**BEFORE THE HEARINGS PANEL
FOR THE QUEENSTOWN LAKES PROPOSED DISTRICT PLAN**

IN THE MATTER of Stage 3b of the
Proposed District Plan

**REBUTTAL EVIDENCE OF HELEN JULIET MELLSOP
ON BEHALF OF QUEENSTOWN LAKES DISTRICT COUNCIL**

12 June 2020

Figure 1: Annotated version of zoning map proposed by Ben Espie for Robert Stewart (31038), showing initial recommended revised zone boundary as white dashed line (to be confirmed following a site visit).

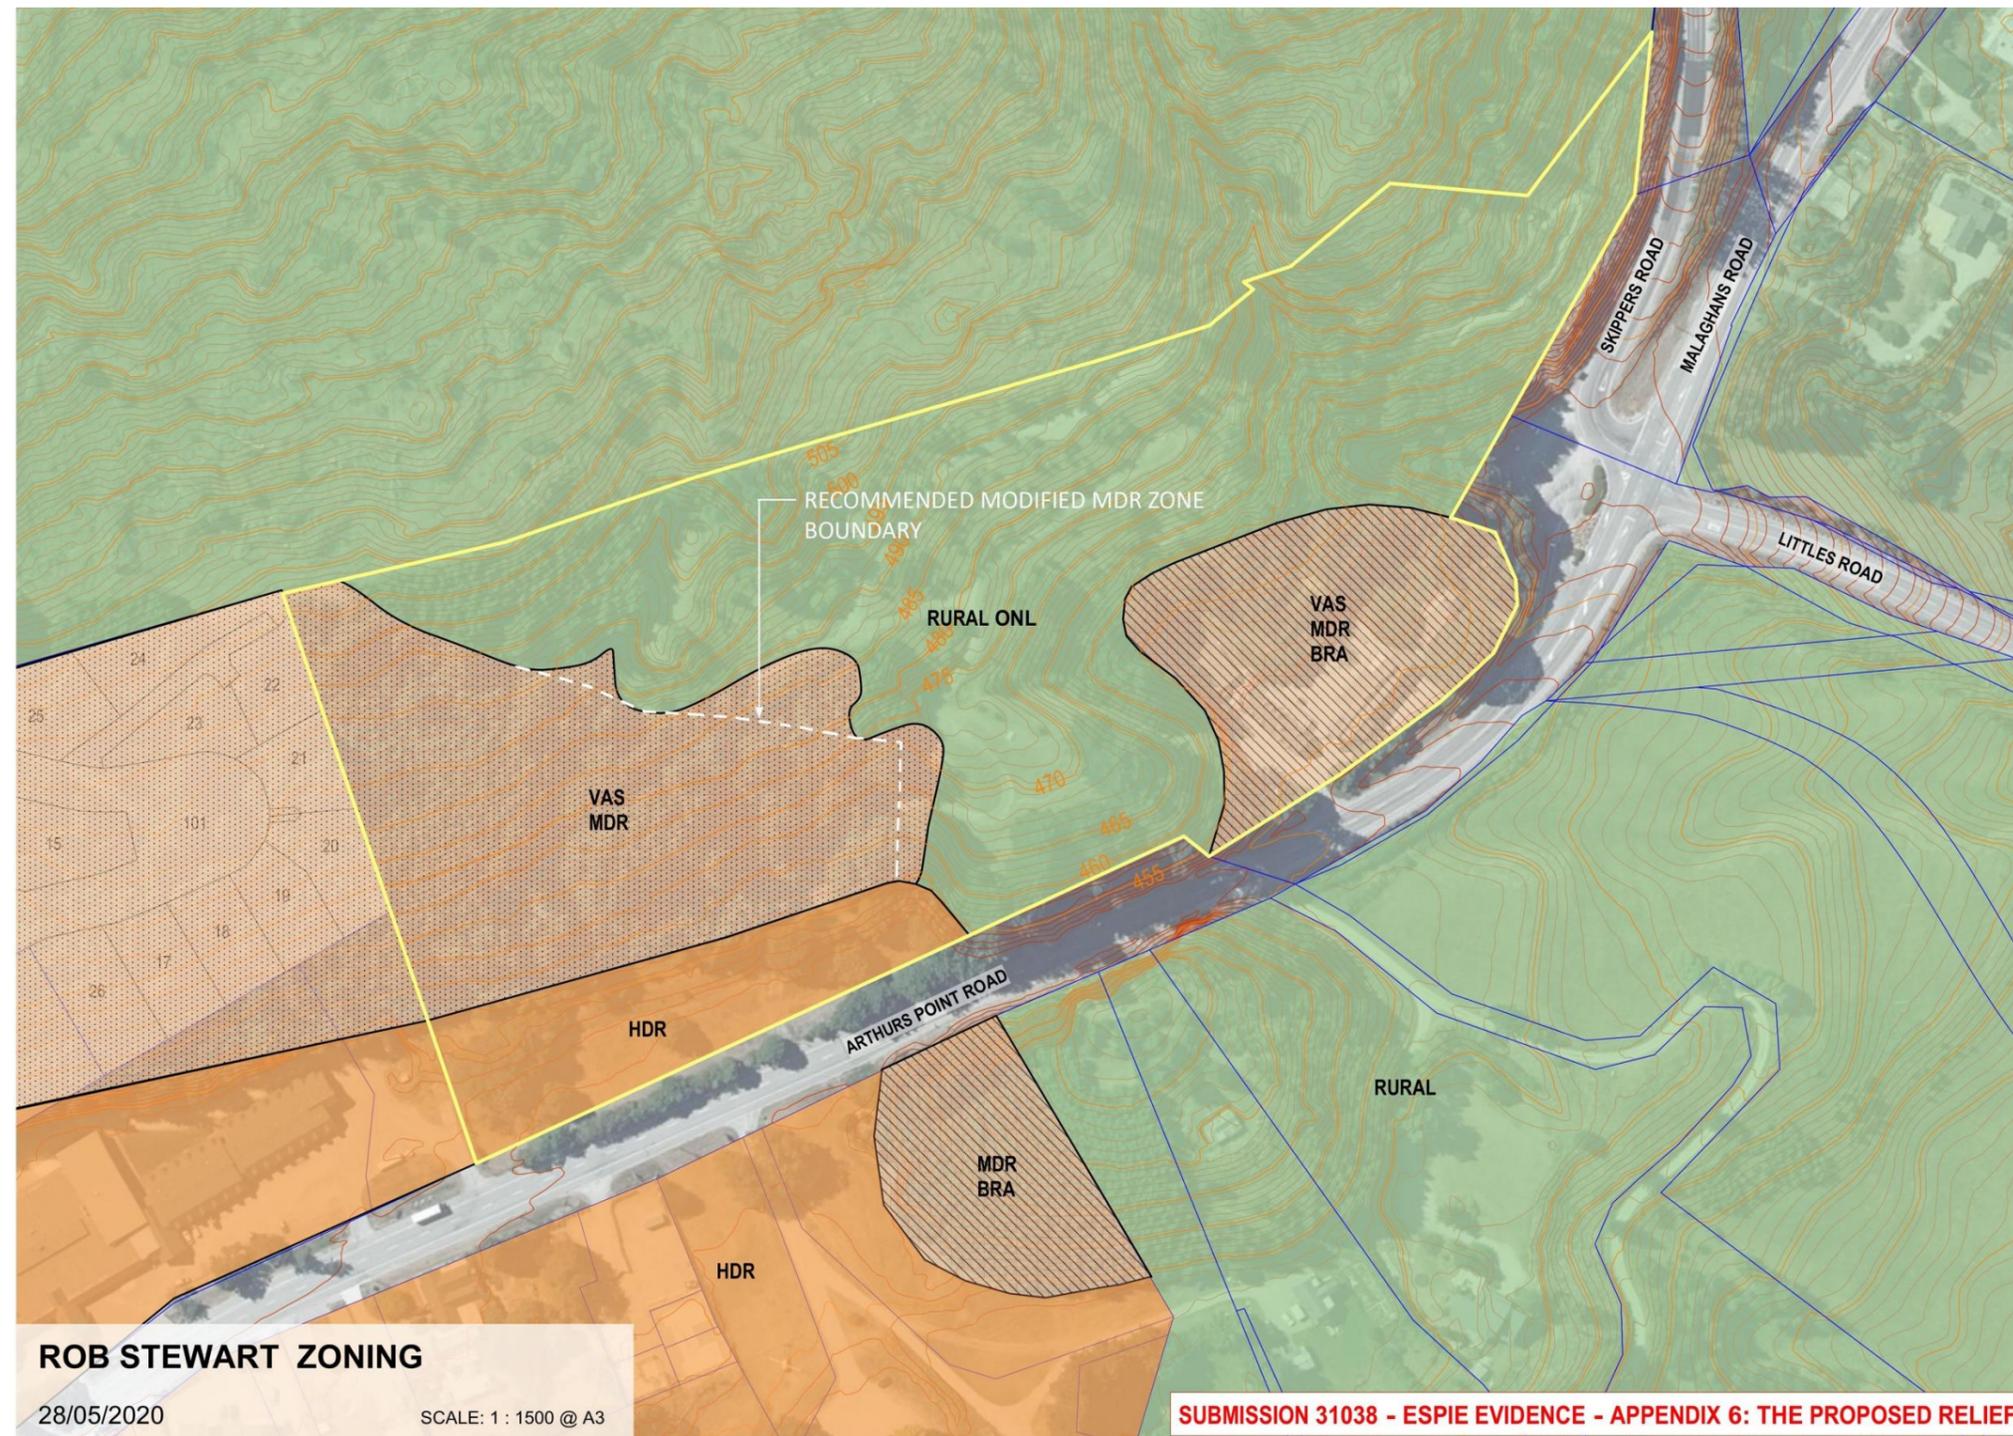
5.3 I largely agree with Mr Espie that the extended area of MDRZ shown in his Appendix 6 would result in a more logical, coherent and landform-related pattern of urban development within Arthurs Point North, and could have fewer adverse effects on visual amenity values and landscape character than the notified zoning. The northern and eastern boundaries of the submitter's proposed MDRZ appear to follow an existing farm track on the property rather than any visual catchment or any logical gradient across the contour. The zone also appears to extend partially onto the bluff/headland that forms the eastern topographical enclosure of Arthurs Point North. I have been unable to make a detailed site visit before finalising this rebuttal evidence to determine where the appropriate boundaries of the MDRZ would lie, but my initial recommendation is that they be reduced on the east to completely avoid the bluff/headland and rationalised on the north to form an even gradient across the slope (refer Figure 1 in Appendix A).

5.5 A consequence of my support for the MDR zoning sought by Mr Stewart is that the boundary of the ONL would coincide with the zone boundary, as recommended and shown in Figure 1, Appendix A to this evidence.
